Exhibit B

Approved Concrete Overhang Geometry

As-Built Concrete Overhang Geometry

Ground Floor:
Relief from the required 10'
Setback/Waiver Request: 6'-6"

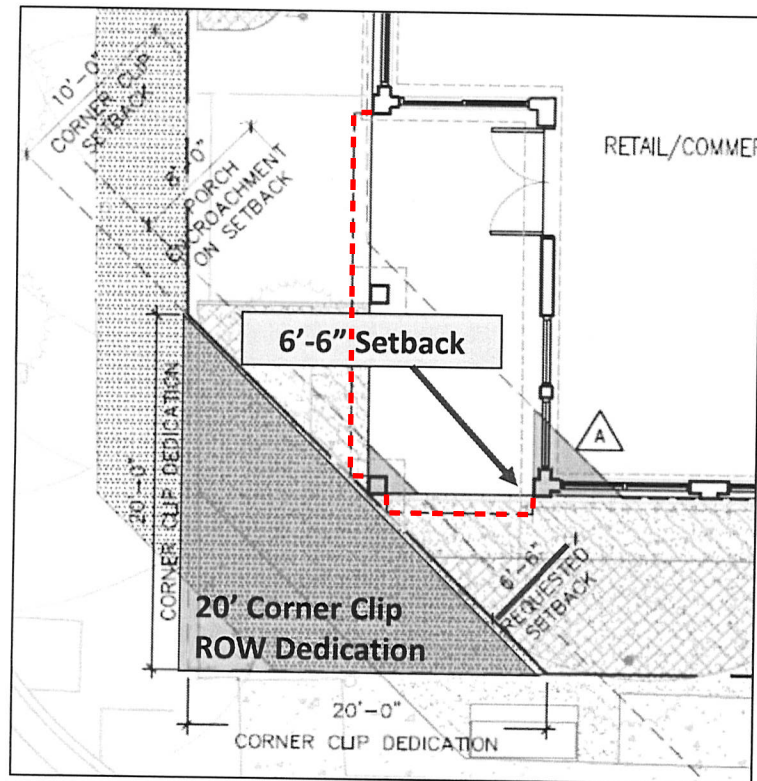
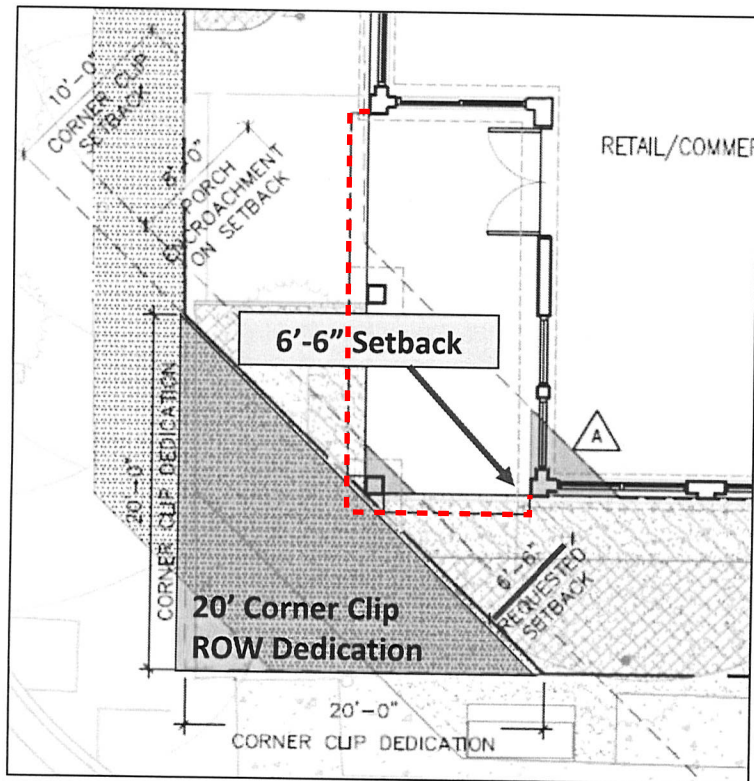
First Floor concrete overhang was built slightly different from what was approved, as the corner wraps around the corner and intrudes in the Corner Clip ROW Dedication.

Second Floor:
Relief from the required 10'
Setback/Waiver Request: 0'-0"

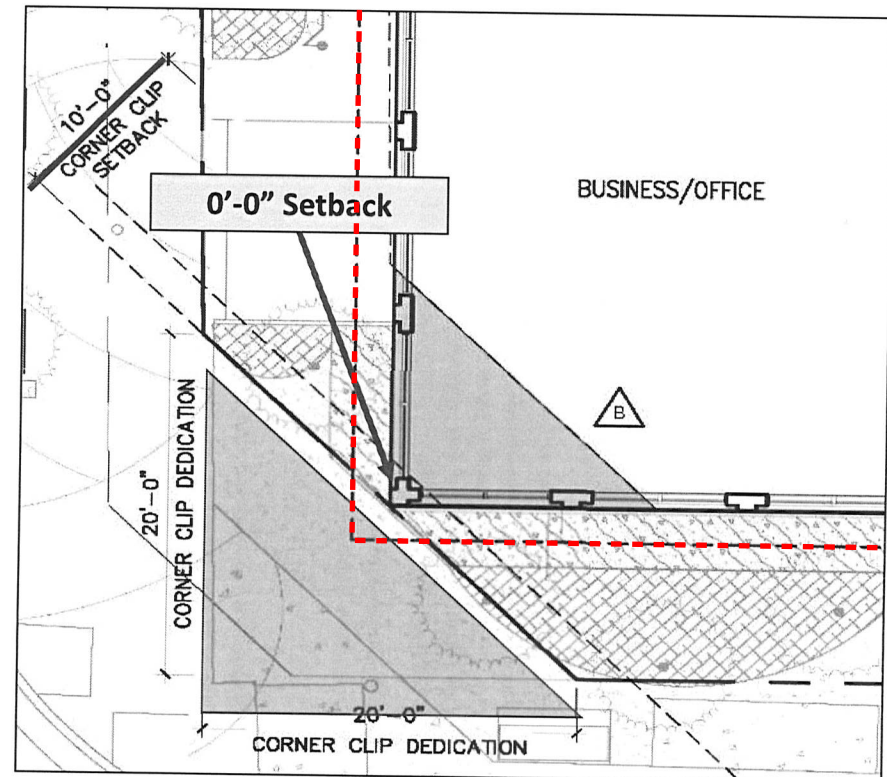
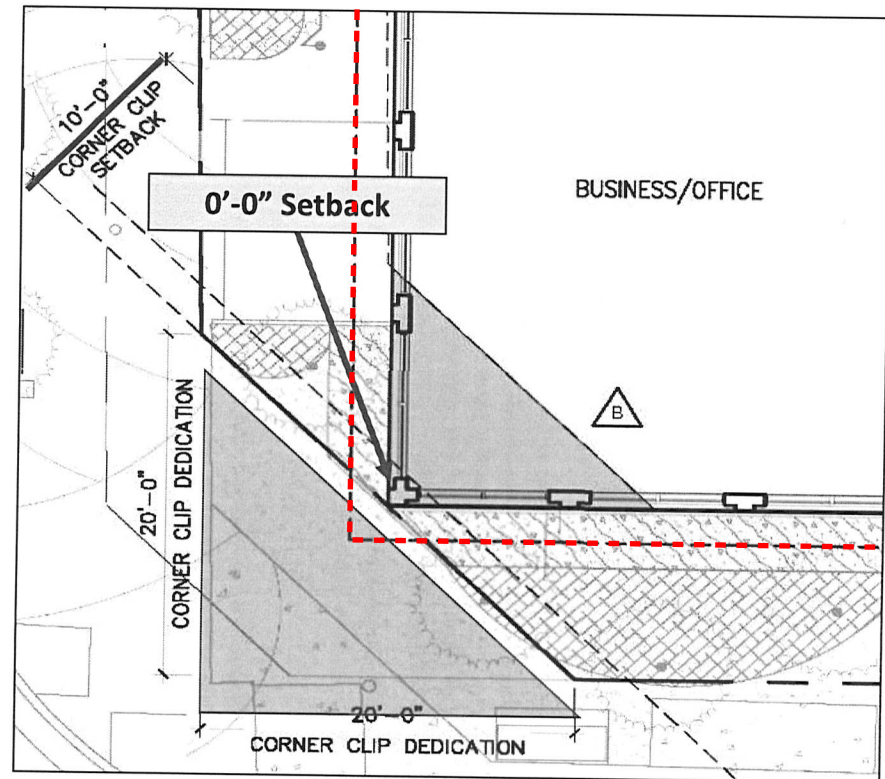
Second Floor concrete overhang was built as approved.
